## PLANNING AND ZONING CASE CHECKLIST

**Project Number:** SP2019-006  
**Project Name:** Plaza at Rockwall  
**Project Type:** SITE PLAN  
**Applicant Name:** KIMLEY-HORN  
**Owner Name:** EXCEL, ROCKWALL LLC  
**Project Description:**

**TO:** Planning and Zoning Commission  
**DATE:** April 9, 2019  
**APPLICANT:** Marla Mauricio; *Kimley-Horn and Associates, Inc.*  
**CASE NUMBER:** SP2019-006; *Plaza at Rockwall*

**RE: AMENDING SITE PLAN (SP2019-006), Plaza at Rockwall**

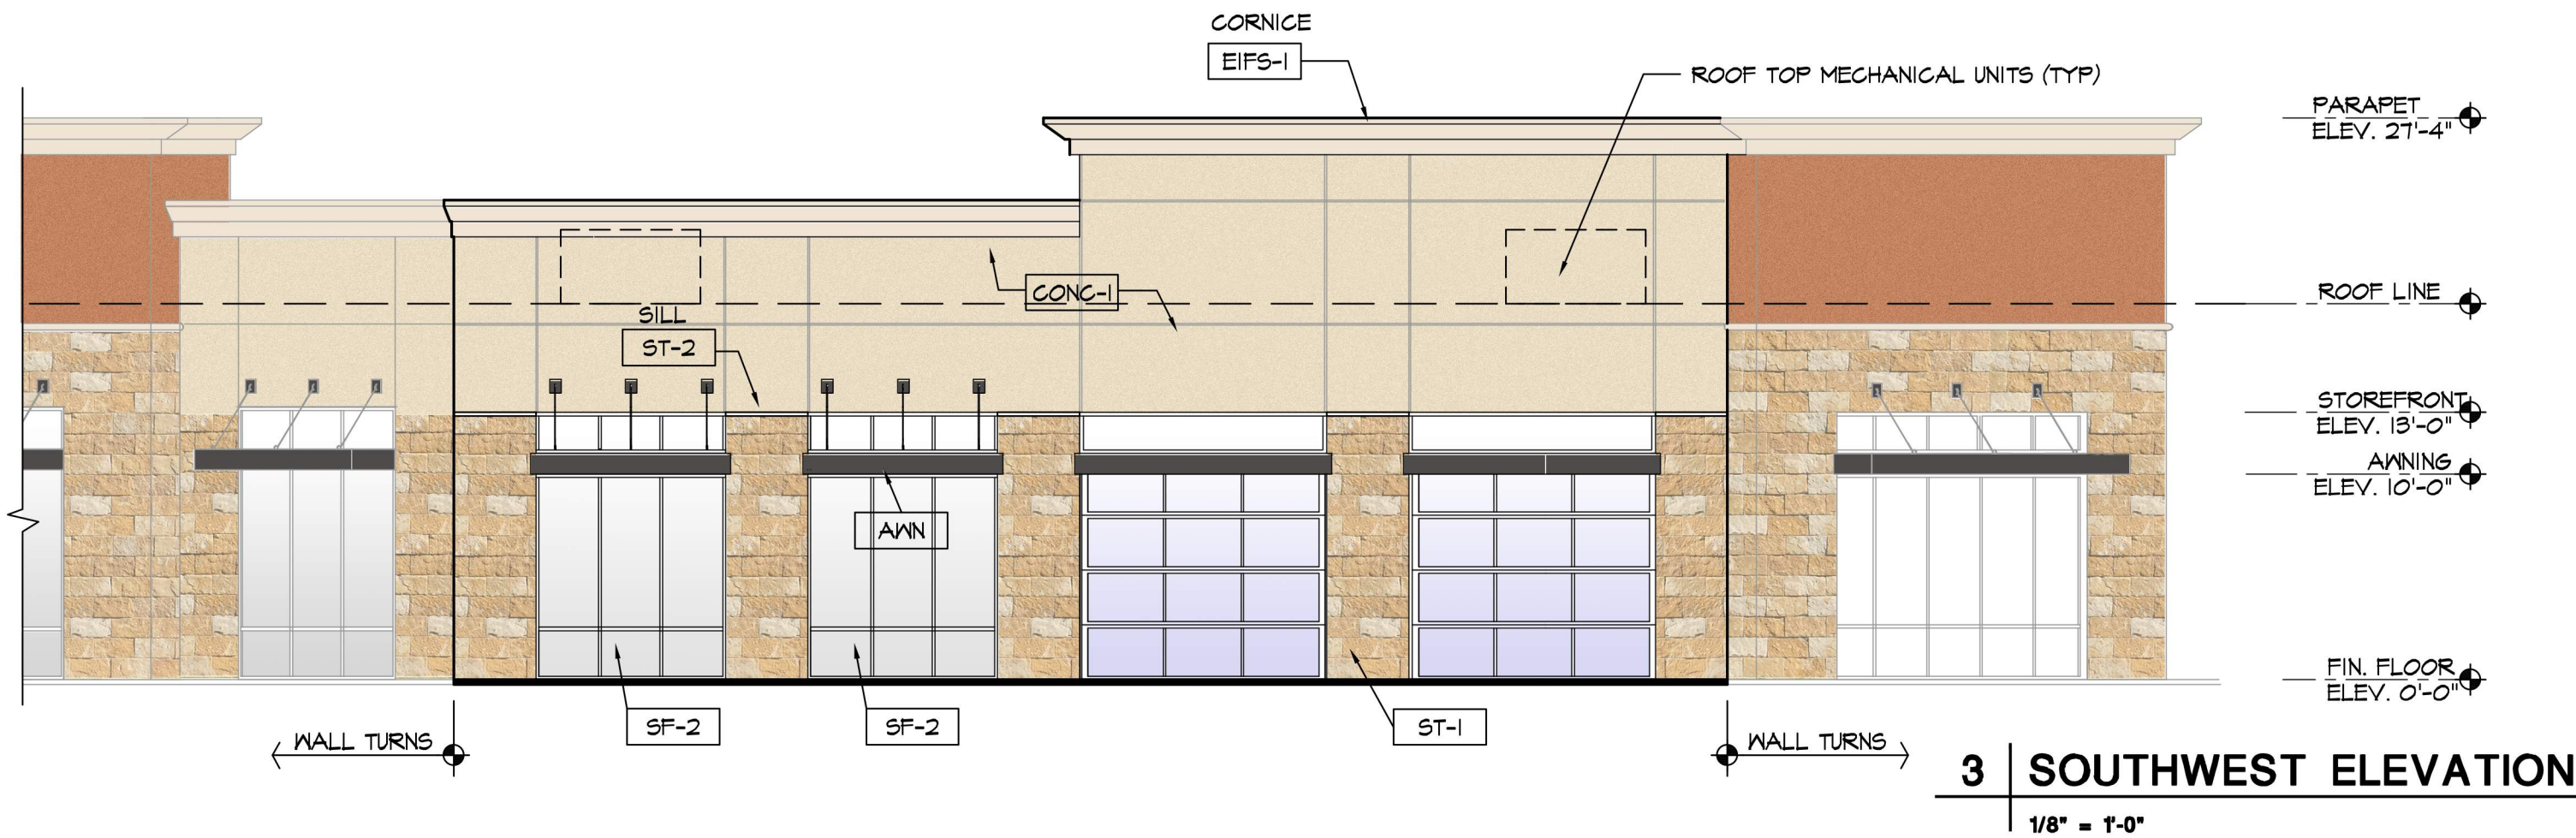
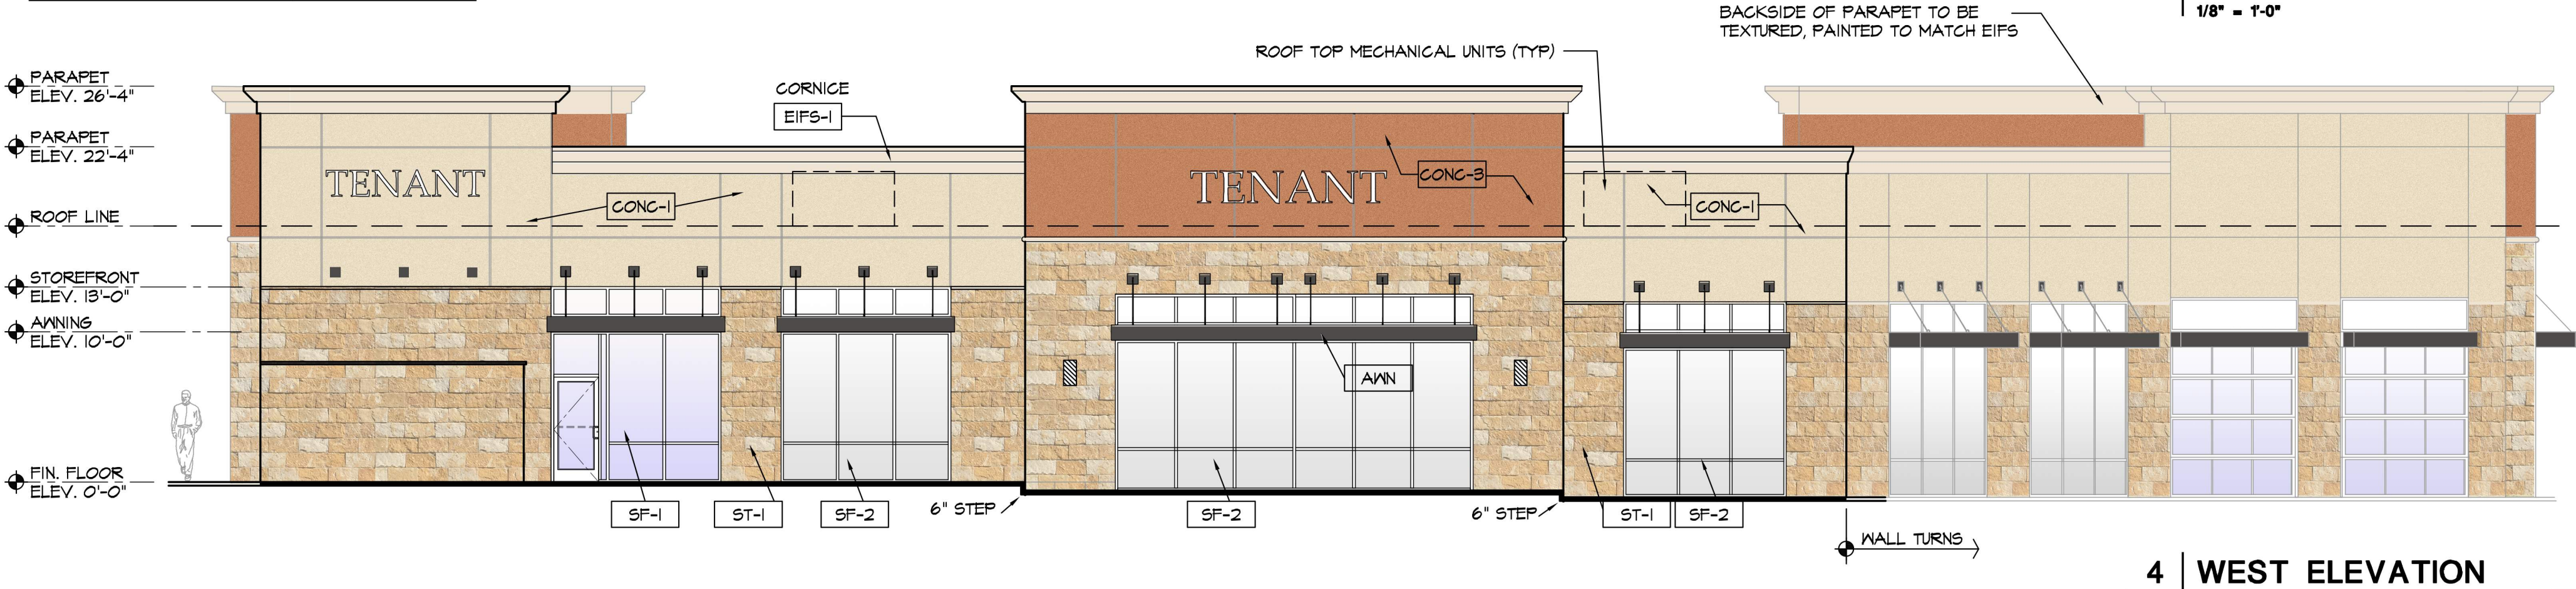
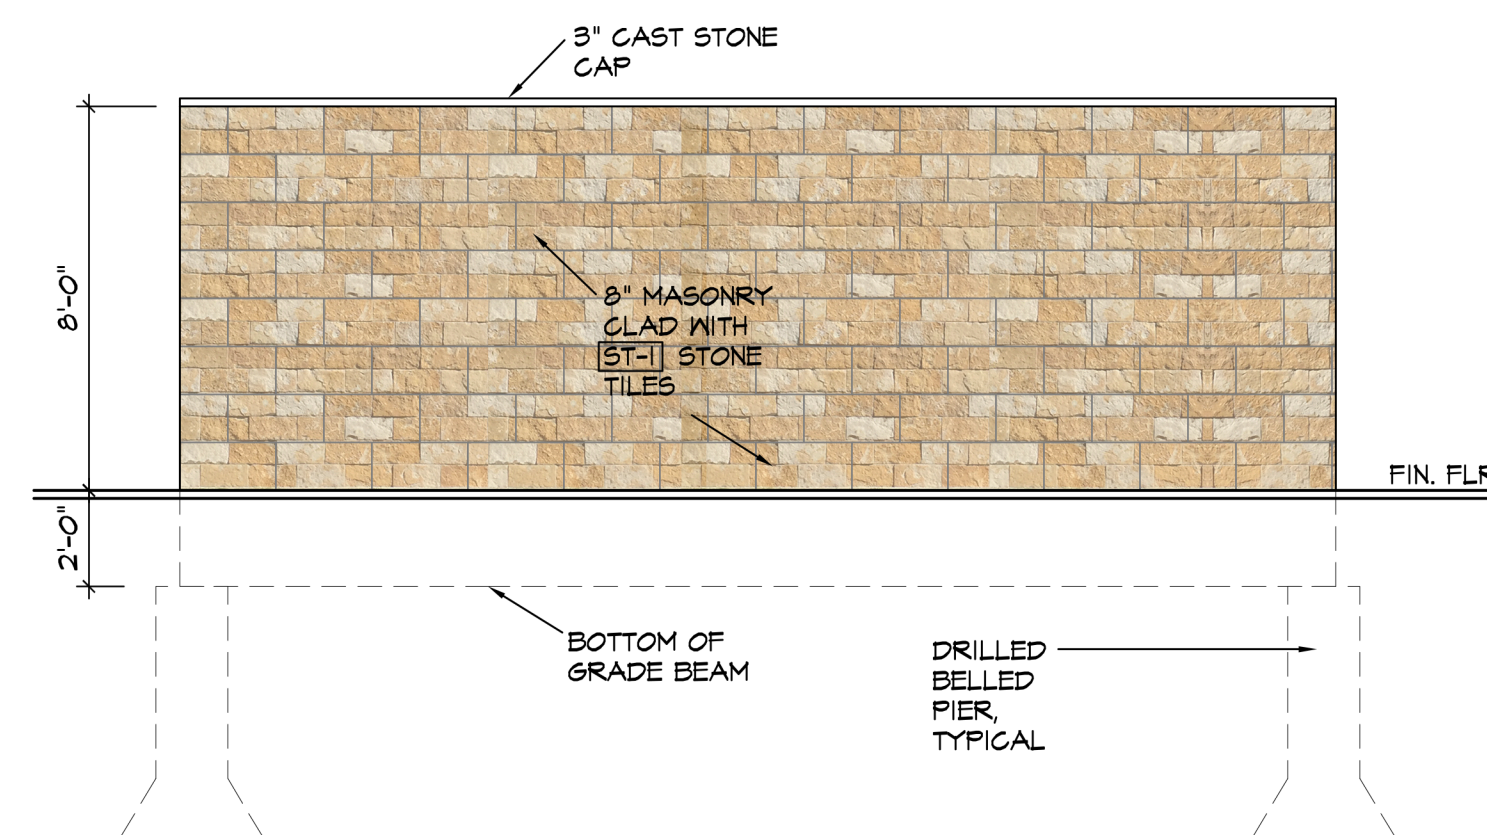
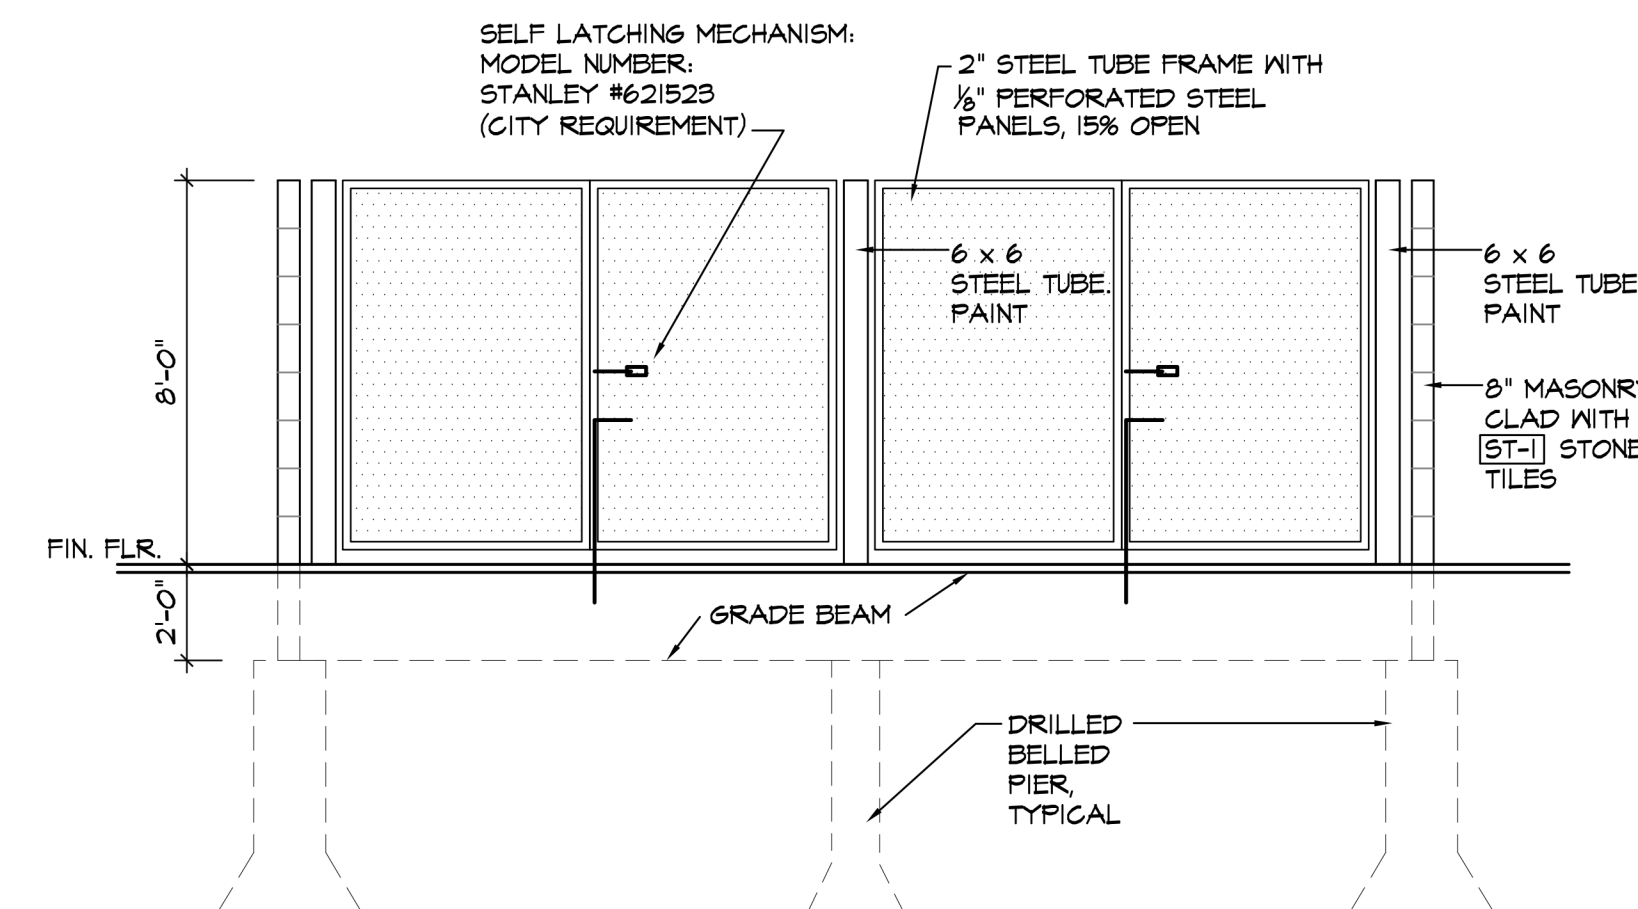
On March 26, 2019, the Architectural Review Board (ARB) reviewed the proposed building elevations and requested that the applicant finish the inside of the parapets, and provide tree wells and lighting elements in the new alley (*i.e. the existing park area*). Additionally, the Architectural Review Board (ARB) requested a rendering of the proposed park area and alley. The applicant has submitted revised building elevations for the Architectural Review Board (ARB) to review and forward a recommendation to the Planning and Zoning Commission at the April 9, 2019 Planning and Zoning Commission meeting.
